Air drier mounting fasteners, replace
VN, VHD

FSB 561-030, Air drier mounting fasteners, replace

(September 2020)

T5162607

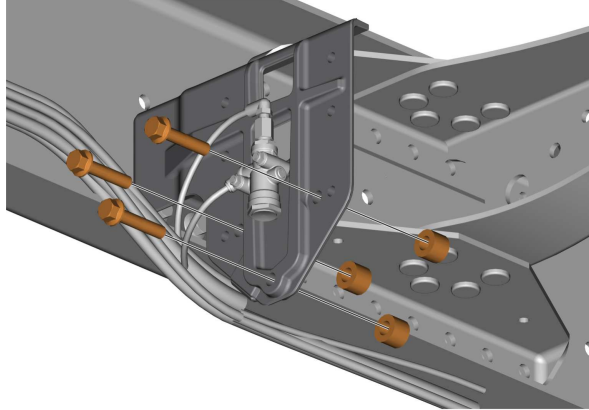
- 1 Remove the screws and air drier.

Note: Sufficient slack is available to remove the air drier without disconnecting the electrical and pneumatic connections.

Note: Secure the air drier with electrical and pneumatic connections.

T5162608

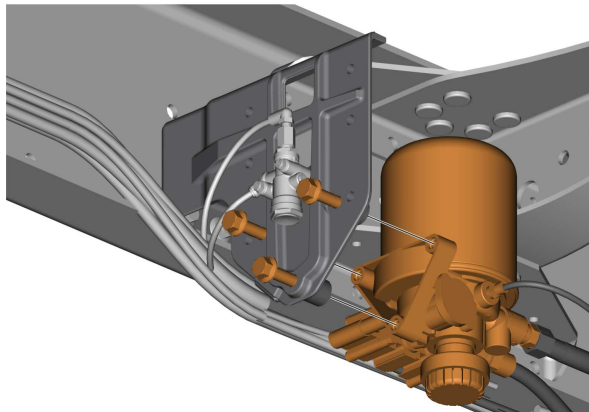
2 Install the new screws and spacer sleeves.

T5162609

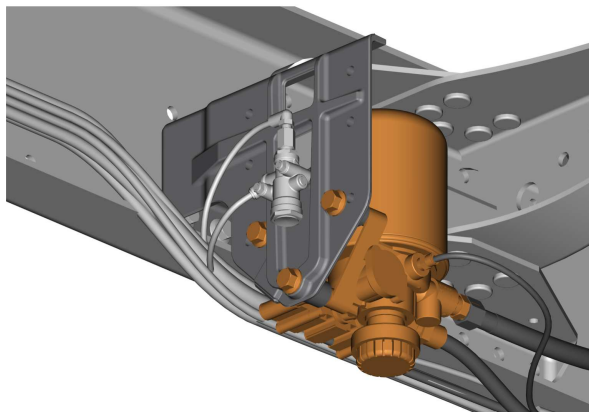
3 Position the air drier and hand tighten the screws.
